PD Modification Application: PRS 26-0008**Zoning Hearing Master Date:** N/A**BOCC Land Use Meeting Date:** January 13, 2026**Hillsborough
County Florida**

Development Services Department

AGENCY REVIEW COMMENT SHEET

2.3 Approved Site Plan (partial provided below for size and orientation purposes. See Section 8.1 for full site plan)

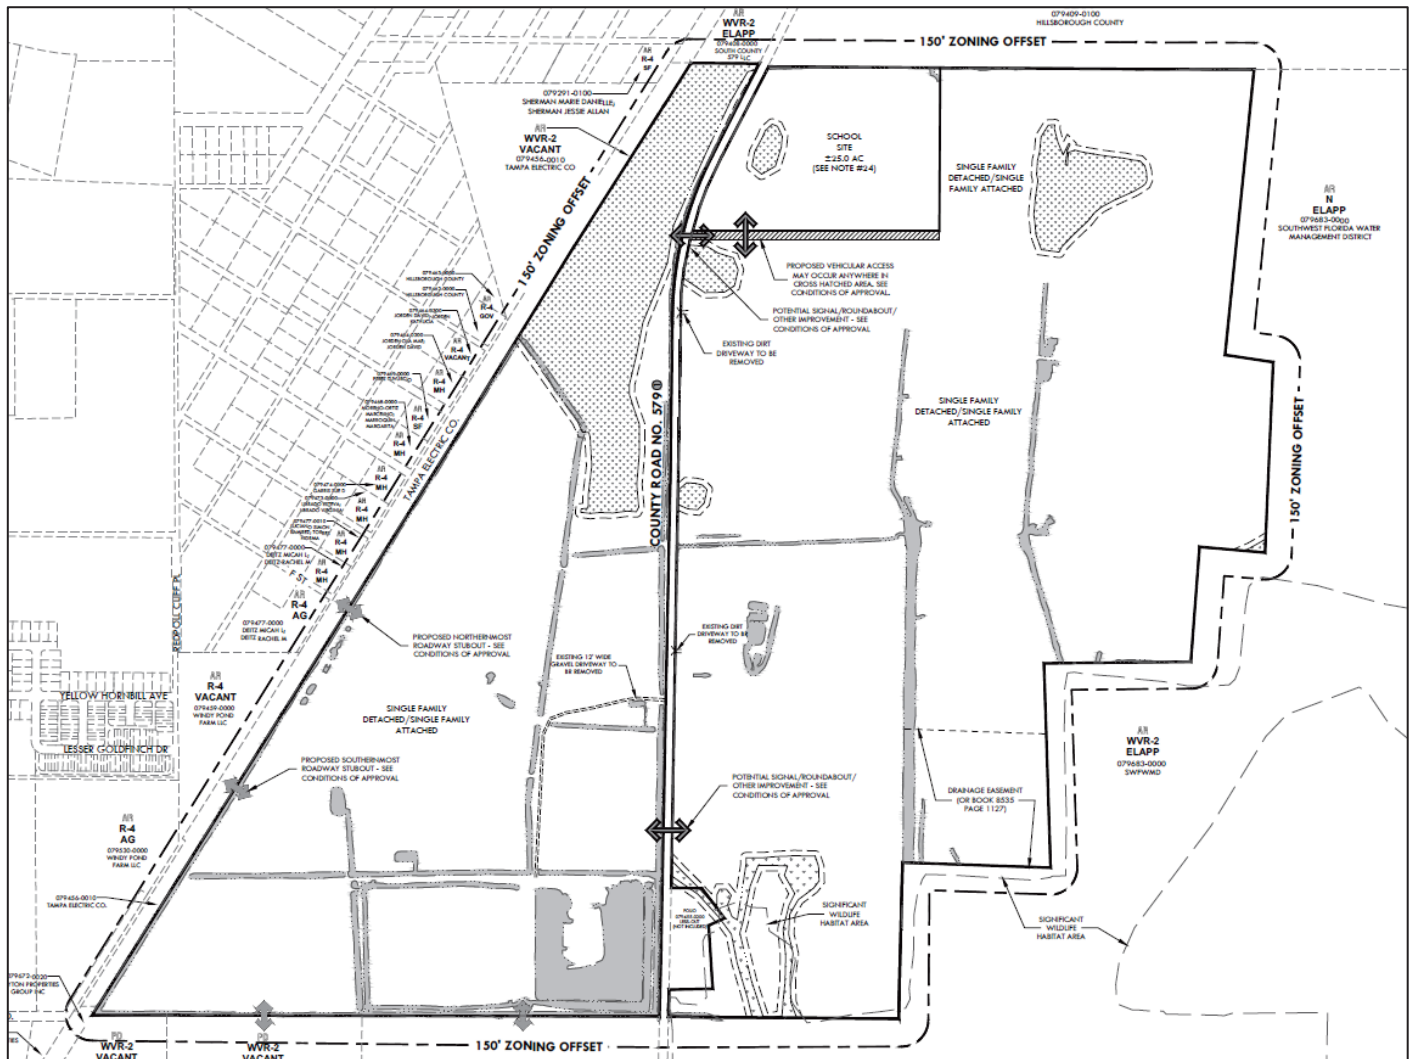
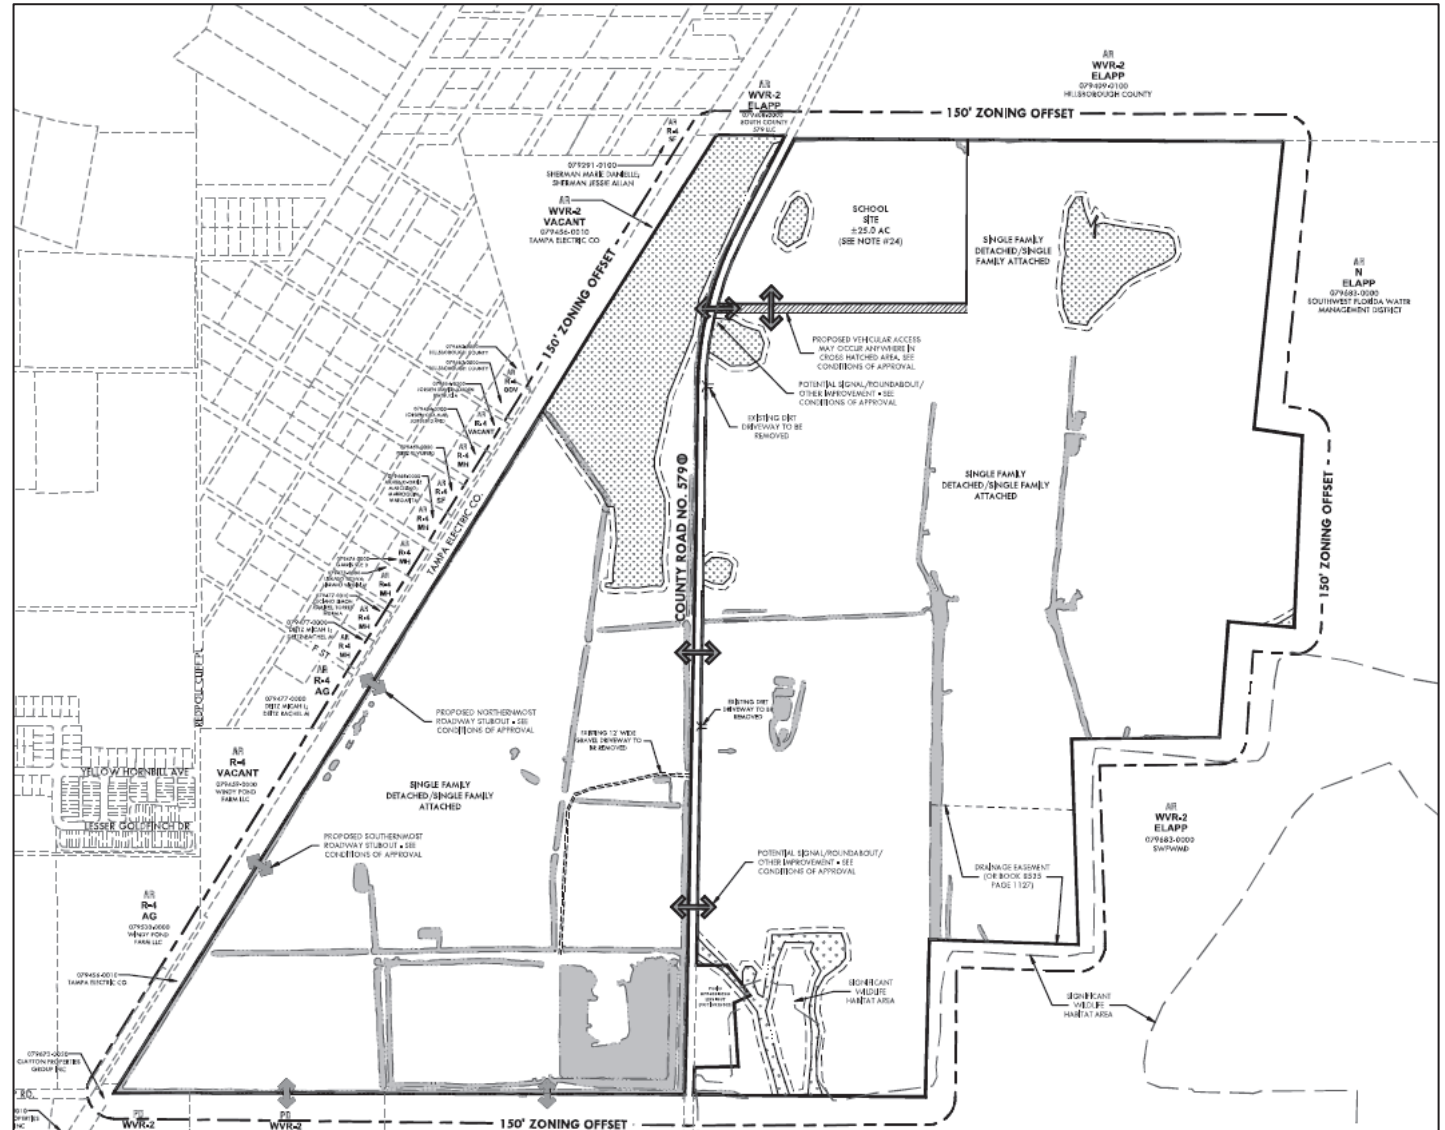
The applicant is requesting a minor modification to reduce the front yard setback for garages and add an additional access onto County Road 579.

The applicant looks to modify Planned Development 25-0469 by amending the single-family home development standards by reducing the front yard setback for garages from 25 feet to 20 feet. Applicant also seeks to add an additional access along CR 579.

Staff does not have any compatibility concerns with the requested modifications.

Approval - Approval of the request, subject to the conditions listed below, is based on the general site plan submitted November 24, 2025.

SITE ACCESS AND CONNECTIVITY

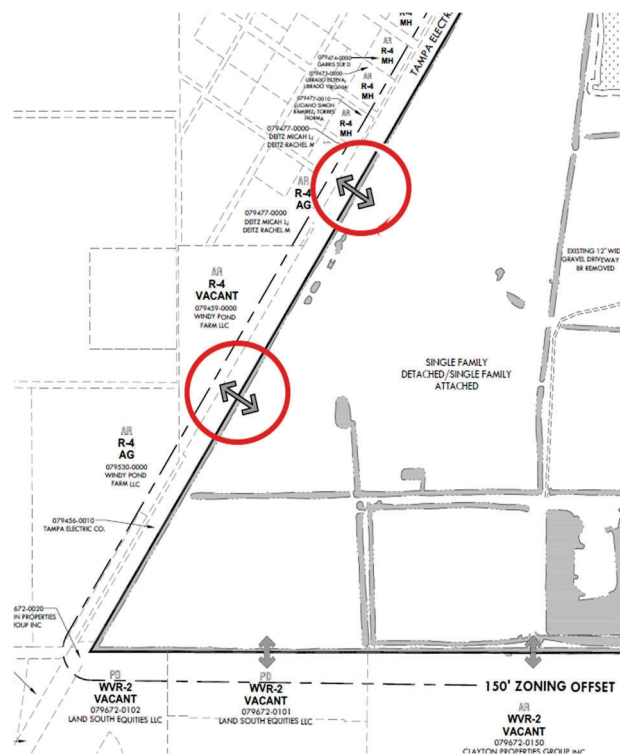
The applicant is proposing to take access to the project via CR 579. One additional access connection is proposed to be added by the applicant for this PRS. A series of roadways will be constructed to accommodate internal project traffic. The applicant's analysis indicated that certain auxiliary (turn) lanes were warranted per Section 6.04.04.D. of the LDC; however, intersections may be required to be signalized. If signalized, auxiliary turn lanes would need to be constructed; however, if the developers choose to pursue installation of roundabouts, auxiliary turn lanes may no longer be needed. As such, staff has deferred the determination of auxiliary turn lanes to the site/construction plan stage. The developer will be required to analyze the need for site access improvements, based on whatever intersection control devices are ultimately warranted, and may be required to install dual lefts into or out of the site depending upon the final type/amount of development and configuration/design of proposed intersections and access control devices. Staff notes that dual receiving lanes or other similar improvements could be needed. Also, if turn lanes on one leg of an intersection are required, the County will require a turn lane on the opposite leg regardless of whether such turn lane is strictly warranted pursuant to Sec. 6.04.04.D. County staff has ensured that access locations as well as the proposed conditions will work together to minimize external impacts from the potential school site to CR 579 to the greatest extent possible.

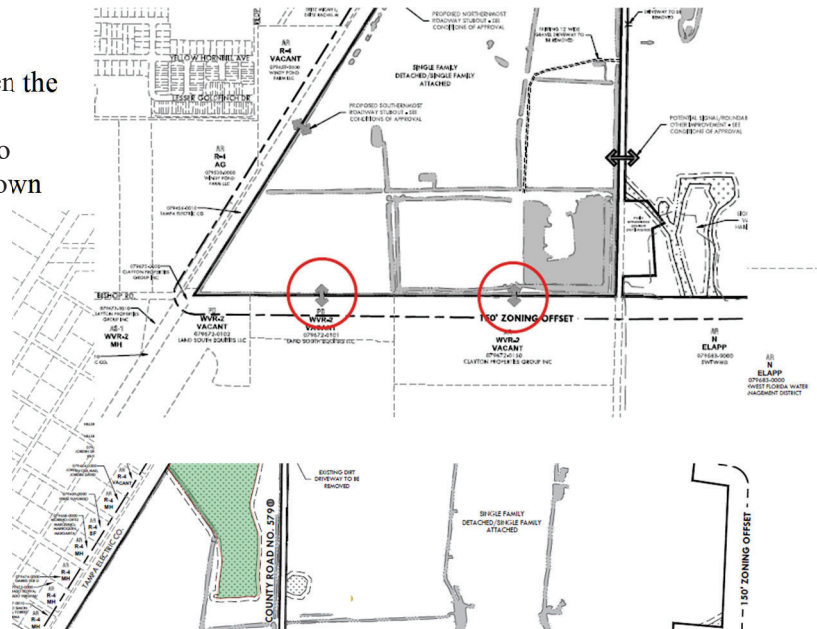
Lands owned by the County, which were acquired through the Jan K. Platt Environmental Lands Acquisition and Protection Program (ELAPP), surround the project along the PDs eastern, northern and southern PD boundaries (of the Eastern Development Area). As such, there are no opportunities for additional connectivity to these areas.

--Overall Analysis and Connectivity--

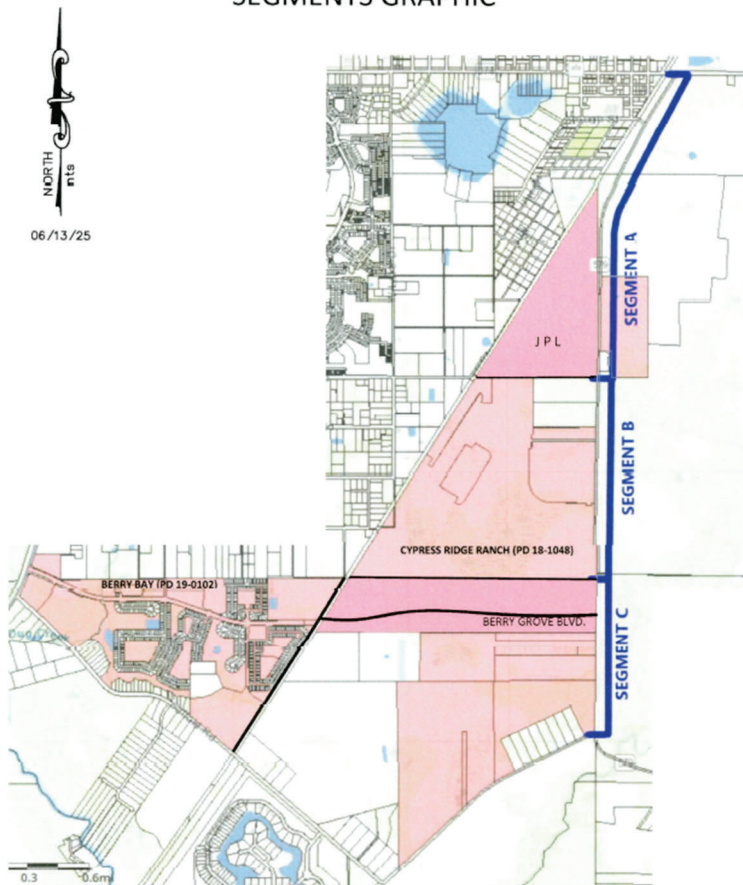
The developer is providing two connections, in addition to the CR 579 north-south corridor, (for a total of three connections provided). Applicant-proposed through road connections are shown circled in red.

SITE ACCESS AND CONNECTIVITY

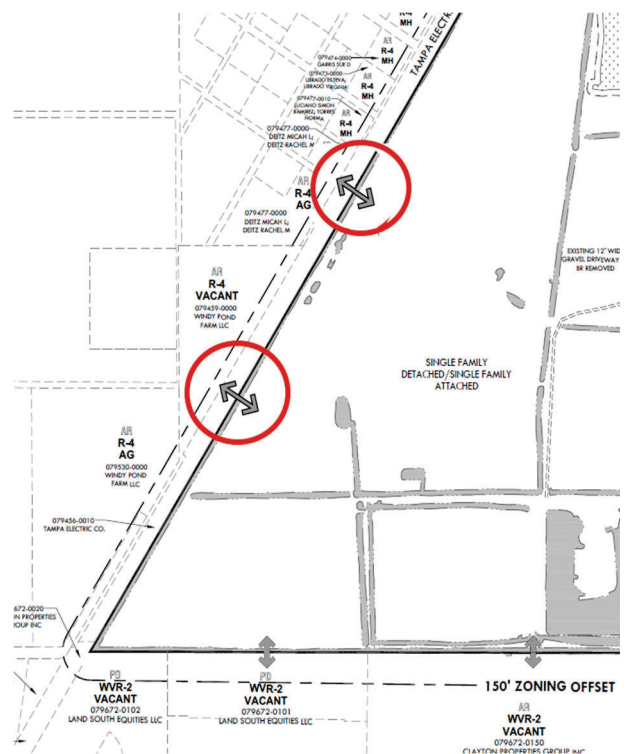
The applicant is proposing to take access to the project via CR 579. One additional access connection is proposed to be added by the applicant for this PRS. A series of roadways will be constructed to accommodate internal project traffic. The applicant's analysis indicated that certain auxiliary (turn) lanes were warranted per Section 6.04.04.D. of the LDC; however, intersections may be required to be signalized. If signalized, auxiliary turn lanes would need to be constructed; however, if the developers choose to pursue installation of roundabouts, auxiliary turn lanes may no longer be needed. As such, staff has deferred the determination of auxiliary turn lanes to the site/construction plan stage. The developer will be required to analyze the need for site access improvements, based on whatever intersection control devices are ultimately warranted, and may be required to install dual lefts into or out of the site depending upon the final type/amount of development and configuration/design of proposed intersections and access control devices. Staff notes that dual receiving lanes or other similar improvements could be needed. Also, if turn lanes on one leg of an intersection are required, the County will require a turn lane on the opposite leg regardless of whether such turn lane is strictly warranted pursuant to Sec. 6.04.04.D. County staff has ensured that access locations as well as the proposed conditions will work together to minimize external impacts from the potential school site to CR 579 to the greatest extent possible.

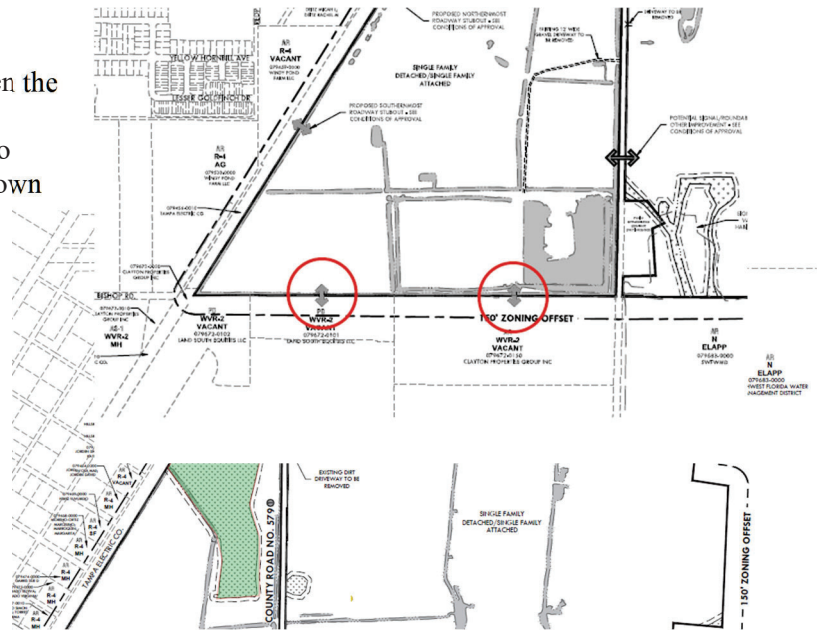
Lands owned by the County, which were acquired through the Jan K. Platt Environmental Lands Acquisition and Protection Program (ELAPP), surround the project along the PDs eastern, northern and southern PD boundaries (of the Eastern Development Area). As such, there are no opportunities for additional connectivity to these areas.

--Overall Analysis and Connectivity--

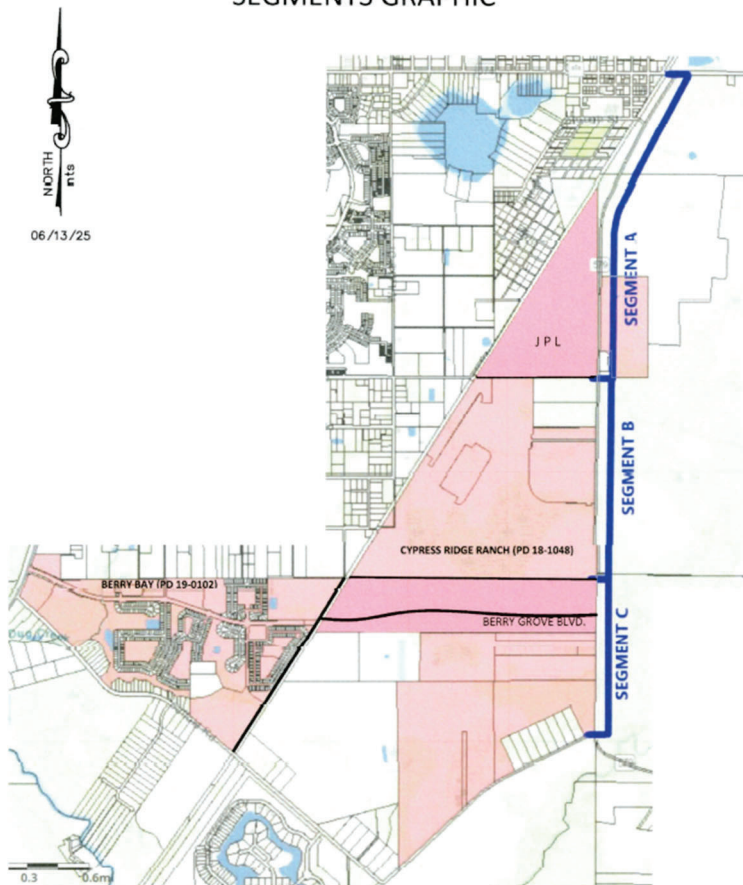
The developer is providing two connections, in addition to the CR 579 north-south corridor, (for a total of three connections provided). Applicant-proposed through road connections are shown circled in red.
